Site Address: 5657 NORTHBOROUGH DR SAC
Parcel No: 201-0610-006
N

Nature of Work: MP2389 1 STORY 7 ROOM SFR

Re: Front Entry Holdowns: Plan 2389 Northborough Village 8-4
O'Connor Freeman Job Number: E020611

Re: Clarification of March 4, 2003 Letter on Front Entry Holdowns
Plan 2389 Northborough Village 8-4
O'Connor Freeman Job Number: E020611

PROBLEMS WITH PLAN 2389

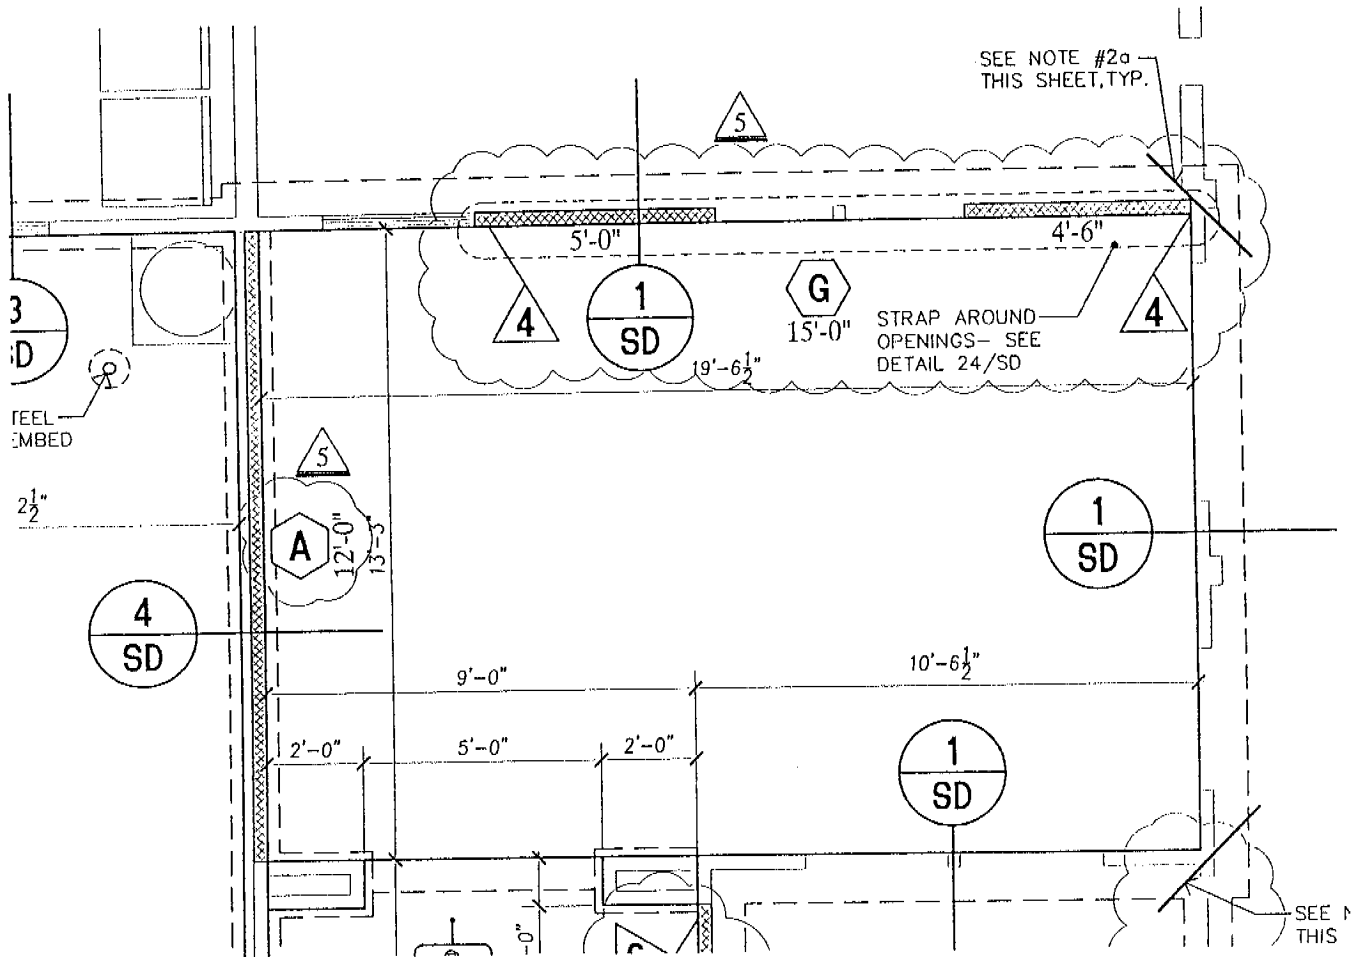
#1 F SHEAR WALL AT ENTRY

5/8 FOR DOOR JAM'S OK FOR STD ENTRY

IF OPTIONAL ANDERSON FRENCH DOORS ARE USED IN DINING.

WE HAVE A PROBLEM. ALSO THE USE OF

THE HD 10A HOLD DOWN DO WE HAVE ANY

OTHER OPTIONS? THE TRAY BULTING IS GOING TO

CAUSE PROBLEMS.

IF WE CAN WE NEED TO DELETE THE

5/8 SHEAR AND CHANGE THE HOLD DOWNS TO

SOMETHING MORE USER FRIENDLY

In response to your request, we have reevaluated the lateral loads to the front entry shear wall in order to determine if the holdown could be changed. As a result of our analysis, we found the shear wall sheathing would remain the same. However, by strapping around the window opening, we can reduce the holdown size. We have adjusted the plans to reflect this information. See the attached partial plan exhibits and structural calculations for reference and review.

SHEAR WALL SCHEDULE

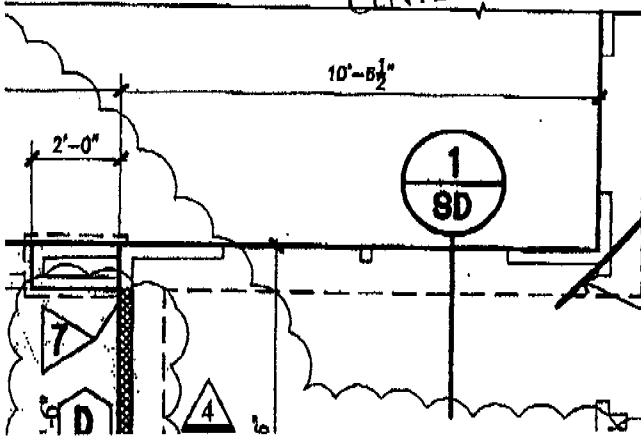
Karl - It has been brought to my attention through my inspector that your letter dated March 4 2003 regarding the Front Entry Hold downs is not worded correctly. Per your letter attached you are saying the shear wall sheathing should remain the same. There is no direction in your letter to indicate the use of the new shear schedule which you included with the letter. All I need is a sentence stating to use the new revised shear schedule.

Shows shear on both sides where new does not.

In our letter dated March 4, 2003, we incorrectly stated the shear wall sheathing could remain the same. This statement created a conflict in the plans between the old and new Shear Wall Schedules. Our intention was to relate the adjusted shear wall design to the new revised Shear Wall Schedule. The correct shear wall construction needs to use 5/8" thick sheathing, which is nailed along all panel edges with 10d nails, spaced at 2" on center and at 12" on center into intermediate field members. This correlates to a Type 'G' shear wall in the New Revised Shear Wall Schedule. *Therefore, the framers are to use the New Revised Shear Wall Schedule to construct the front shear walls of Plan 2389.* The reason for the adjustment in the Shear Wall Schedule came about by attempting to further subdivide shear panel requirement with 4" edge nailing into two separate designations that more accurately represent the UBC requirements and allows for some cost savings in the material to construction the building in this project. See the attached copy of your fax for further reference.
